THE NATIONAL BOARD
OF BOILER AND PRESSURE VESSEL INSPECTORS

NATIONAL BOARD INSPECTION CODE COMMITTEE

MAIN SESSION MINUTES

Meeting of July 17th, 2024
Louisville, KY

FIGURE S2.10.4.2-b

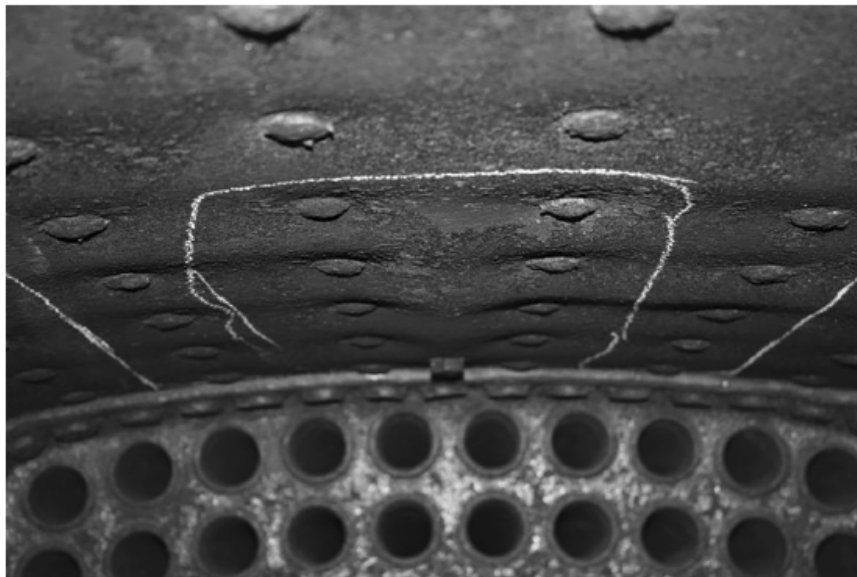
Item Number: 24-23	NBIC Location: Part 2, S2.10.4.2	Attachment Page 91
General Description: Review Verbiage in Part 2, S2.10.4.2		
Subgroup: SG Historical Task Group: None assigned. Submitted by: Michelle Vance		
Explanation of Need: What is the meaning of "pillow/mattress-effects"? Is there a better way to describe this? Is this phrase normally understood outside of the US/by someone who may not speak English?		
July 2024 Action: Mr. Seime presented the proposal for this item. A motion was made, seconded, and unanimously approved to accept the proposal.

- 1) Plate may only be repaired using a flush patch, in accordance with NBIC Part 3, Supplement 2.
- 2) Where a deformation is to be repaired, all portions of the deformity shall be repaired. For example, for contiguous-continuous bulging where only some bulges exceed allowable deformation, the entire bulged area shall be repaired (See Figure S2.10.4.2-b). Unrelated bulges separated by non-deformed plate shall be independently evaluated.
